SUNDRY NOTICES AND REPORTS ON WELLS (DO NOT USE THIS FORM FOR PROPOSALS TO DRILL OR TO DEEPEN OR PLUG BACK TO A DIFFERENT RESERVOIR. USE "APPLICATION FOR PERMIT" (FORM C-101) FOR SUCH PROPOSALS.)		WELL API NO. 30-025-40410

2. Name of Operator ConocoPhillips Company		6. State Oil & Gas Lease No.
3. Address of Operator 913 N. Eldridge Parkway Houston, TX 77079		7. Lease Name or Unit Agreement Name Red Hills West 16 State

4. Well Location Unit Letter D : 180 feet from the N line and 640 feet from the W line Section 16 Township 26S Range 32E NMPM County Lea		8. Well Number #1H

Operator: CONOCOPHILLIPS COMPANY 600 W. Illinois Avenue Midland, TX 79701	OGRID: 217817
	Action Number: 90399
	Action Type: [C-103] NOI Plug & Abandon (C-103F)

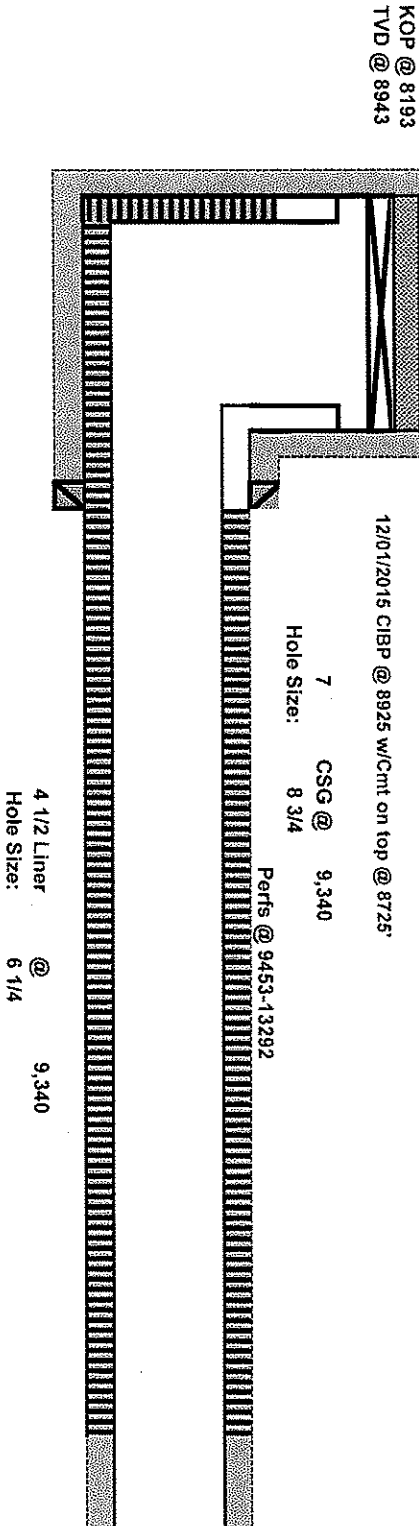
Drill out existing CIBP and cement at 4479 Spot 40 sx Class C 5900 WOC & tag Spot 50 sx Class C 4540 WOC & tag

4" diameter 4' tall Above Ground Marker

Note changes to procedure
